**REQUEST FOR TENDER
ORANGUTAN OUTDOOR EXHIBIT CONSTRUCTION
RFT#: TZC T 57-2019-12
ADDENDUM # 2**

Date Issued: 2020 January 15
Project Name: **Toronto Zoo Orangutan Outdoor Exhibits**
To: Ben Knoop
Toronto Zoo
361A Old Finch Avenue
Toronto, ON M1B 5K7
Project Number: 18-1-086
RFT Reference No.: TZC T-57-2019-12 (issued 2019-12-17)

ADD #A002

SCALE: AS NOTED
DECEMBER 11, 2019 **AR-101**

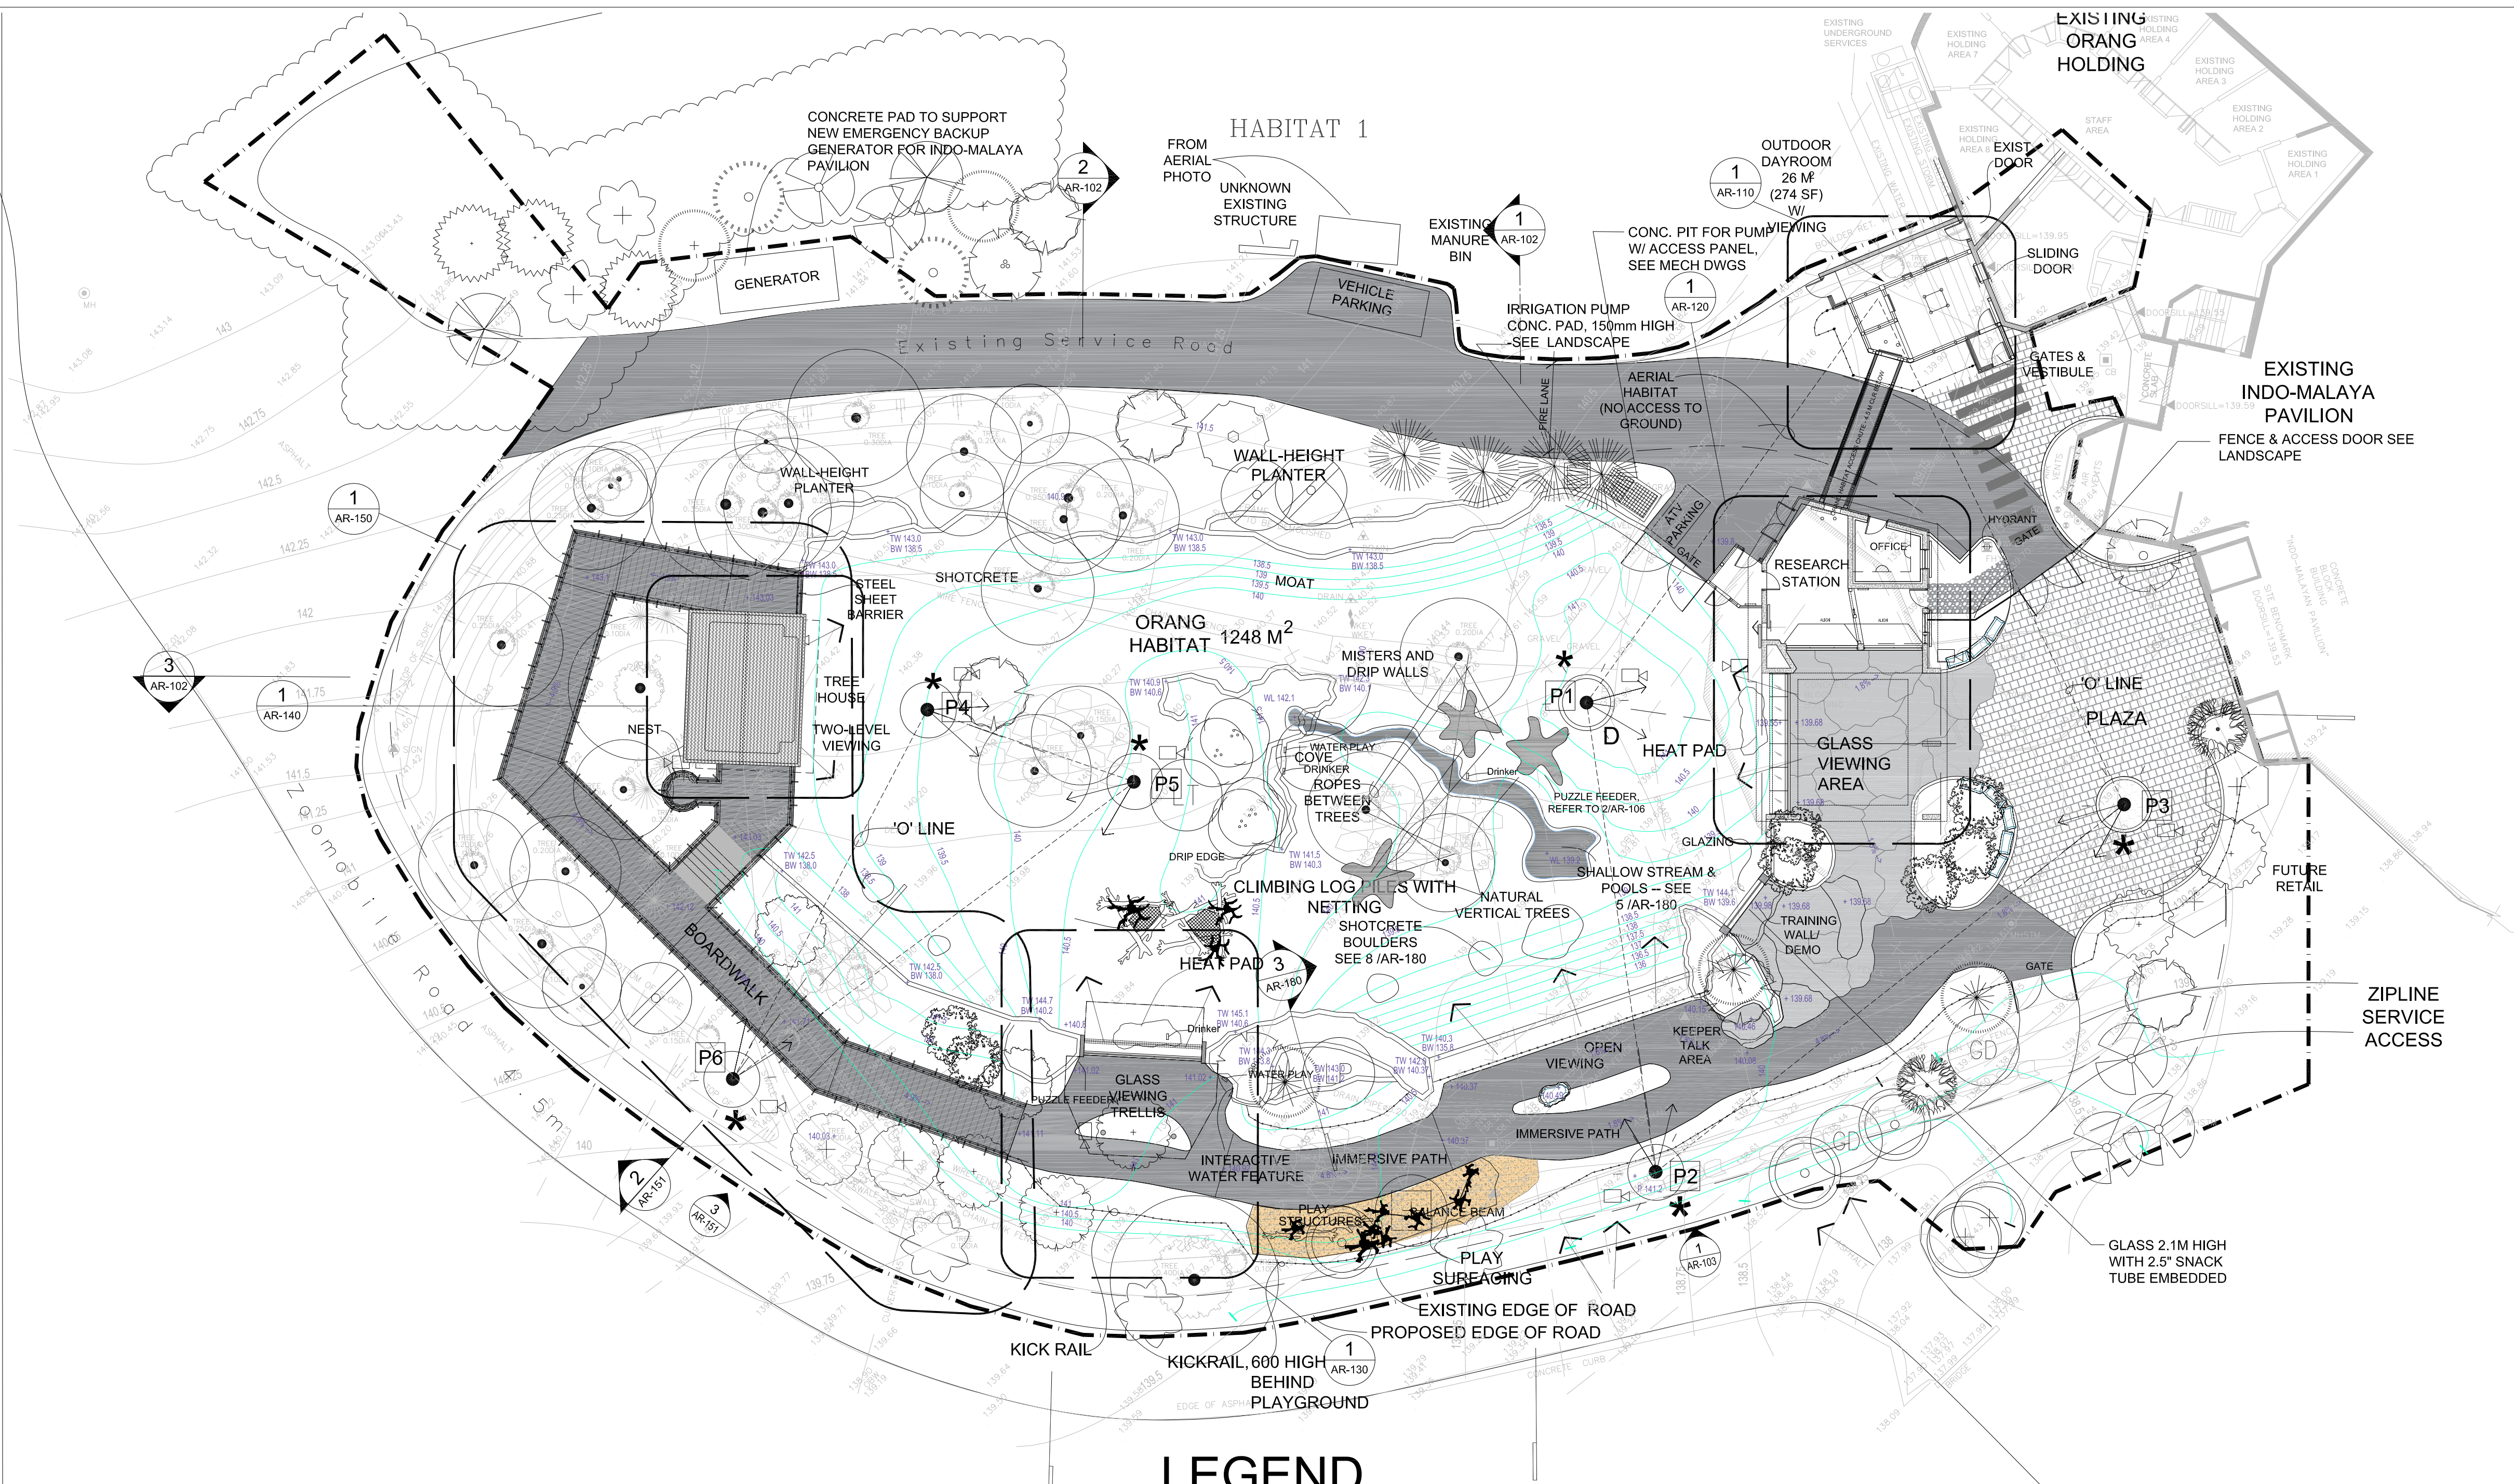
Drawing Series	Drawing No.	Drawing Title	Revision Description	#
ARCHITECTURAL GENERAL				
	AR-007	SETTING OUT PLAN FOR CASSION LAGGING & RETAINING WALLS	Added dimensions & angles for lagging and retaining walls	4
HABITAT 1	AR-100	DEMOLITION PLAN	Added Note "Turnover all doors & frames to zoo" for concrete building to be demolished	4
	AR-101	LAYOUT AND MATERIAL PLAN	Extends New Generator (prepared by McGregor Allsop) area scope	4
	AR-104	CLIMBING POLE DETAILS	Revised distance of pole to edge of platform from 750mm to 900mm	4
	AR-110	DAYROOM PLAN & EXISTING PLANS	1.Extends edge of platform to be 1150mm from cental of post ; 2.revised note:climbing bar anchor to eisting Building	4
	AR-111	DAYROOM SECTIONS	1.Extends edge of platform to be 1150mm from cental of post ;2.Added wall section of ex. holding bldg; 3. Change from flexible mesh to S.S. cable mesh; 4. Change from steel mesh to rigid mesh steel WWM; 5.Remove note"50 X 100 X 6 steel mesh"	4

4.10. S-230

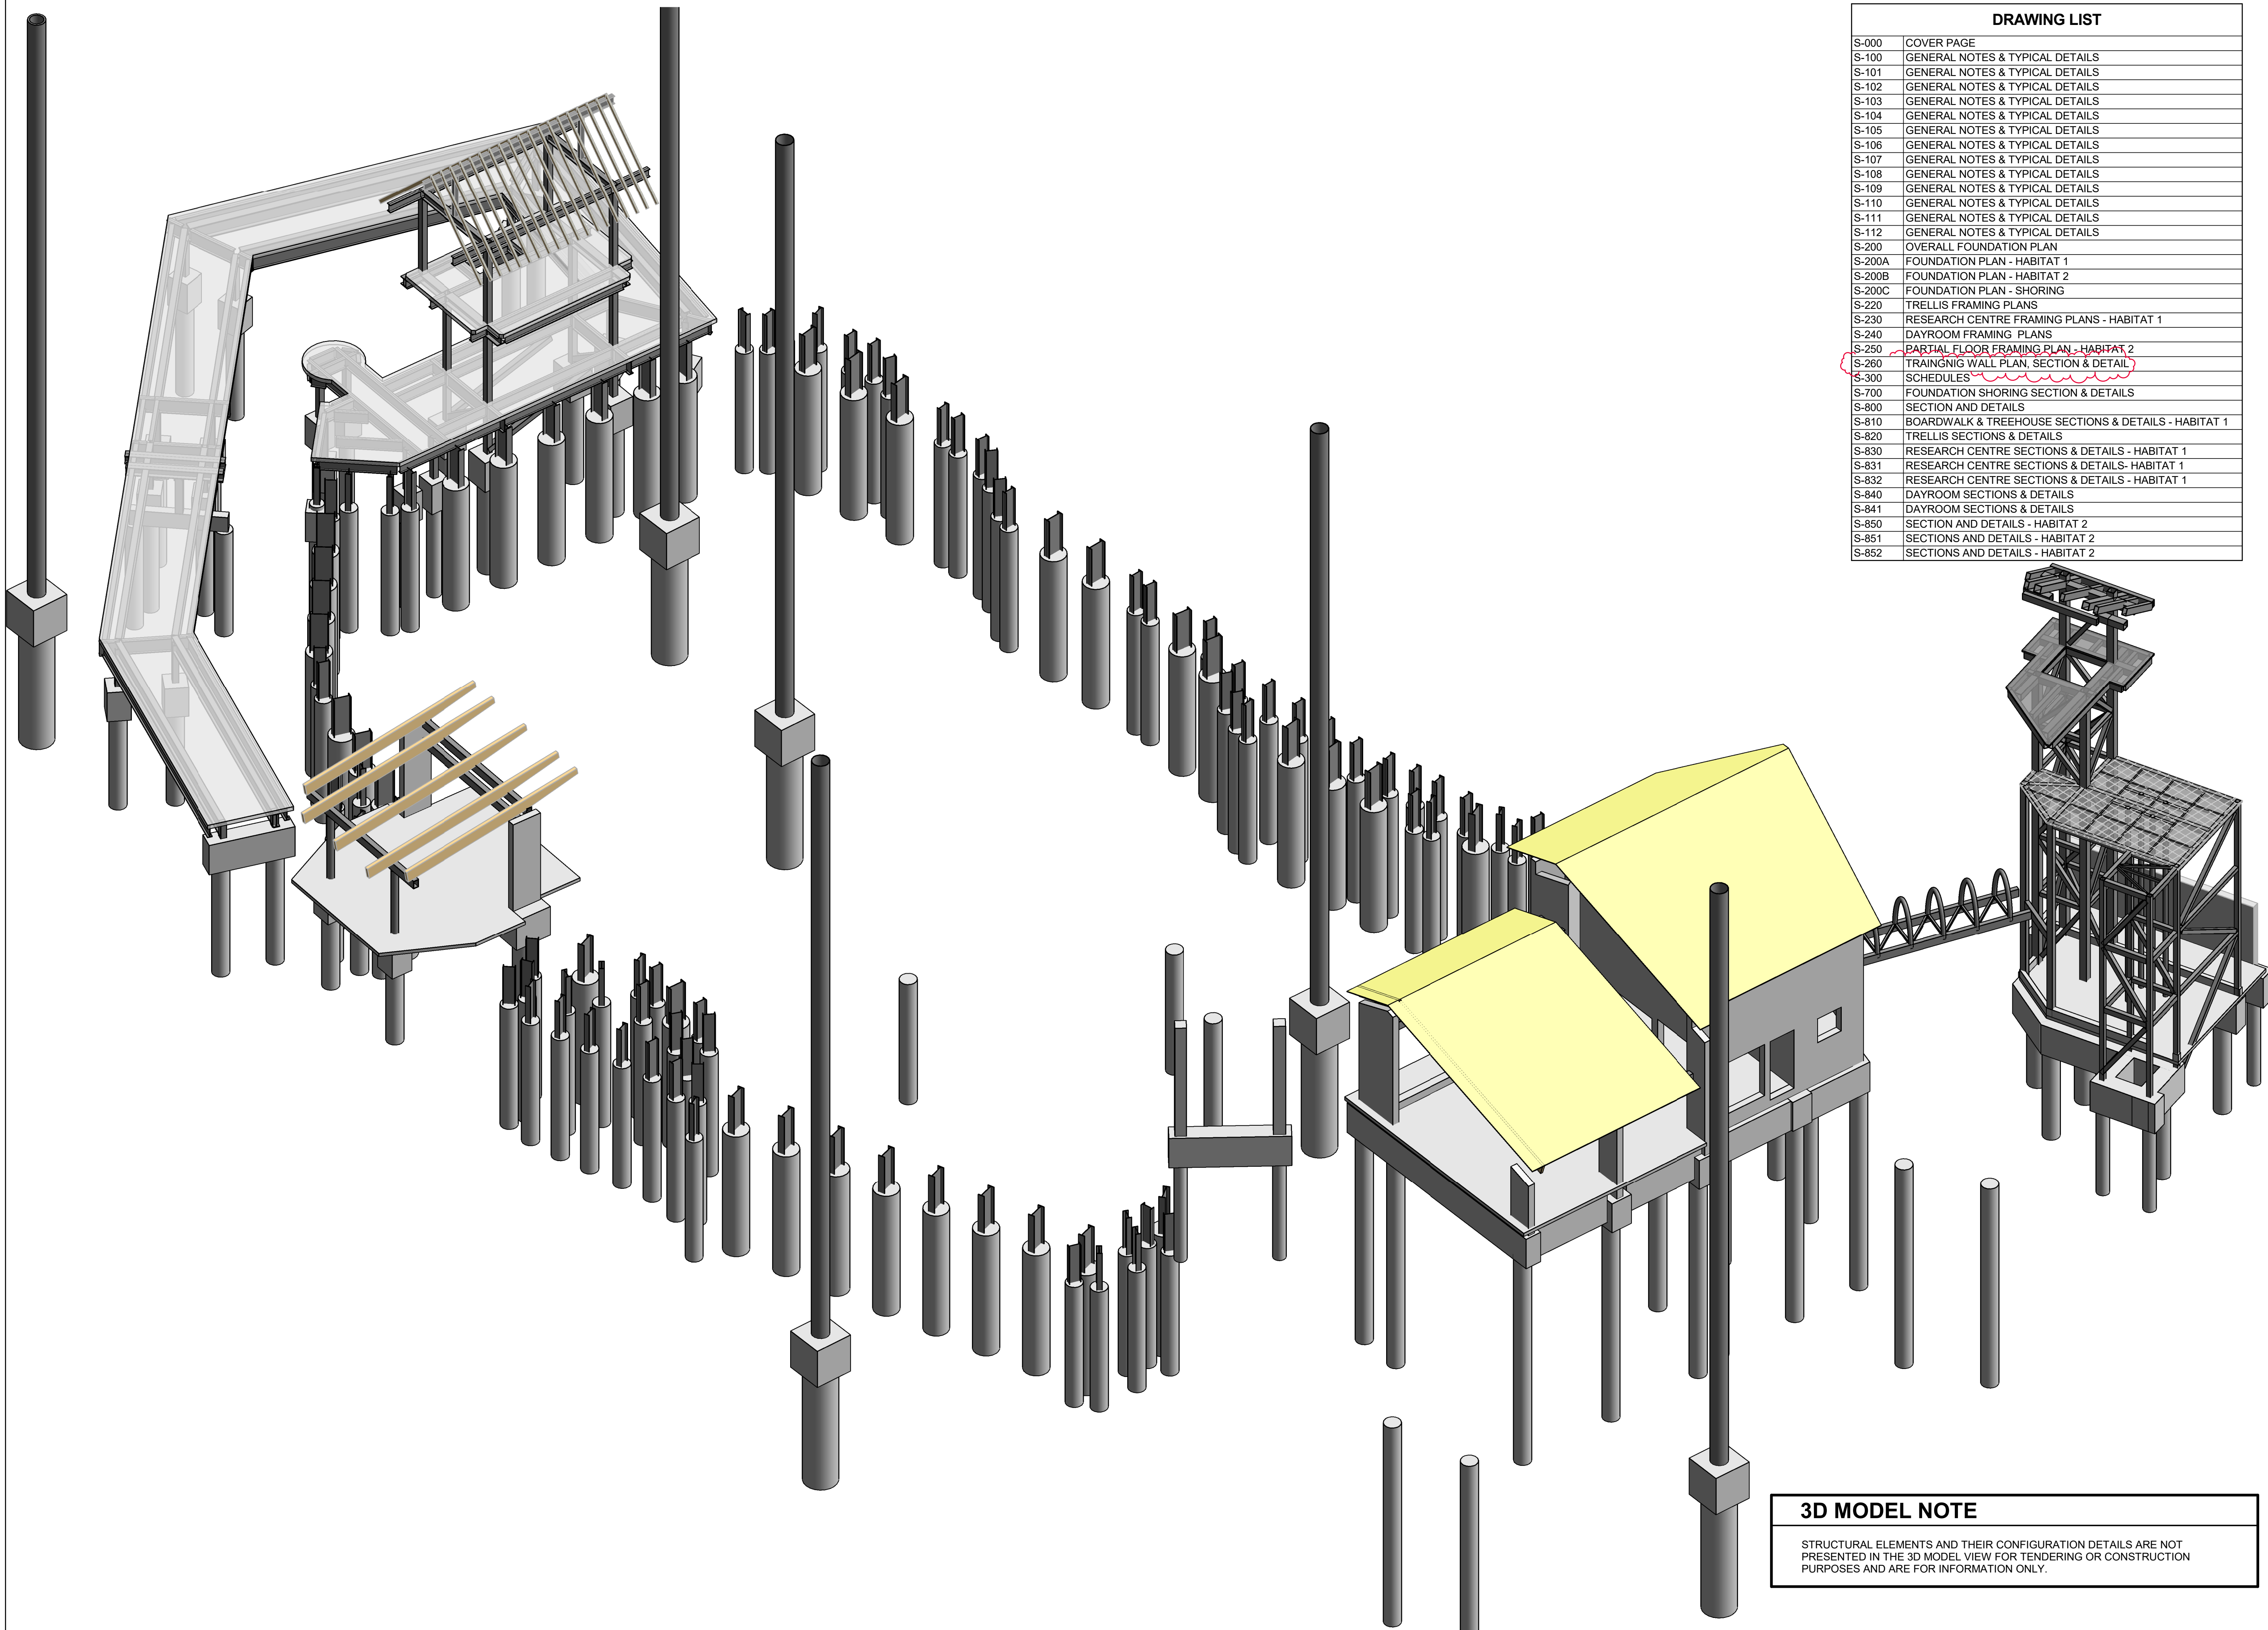
- a. Longitudinally slotted connection added to transfer corridor beam
- b. Extent of grade beam corrected foundation plan
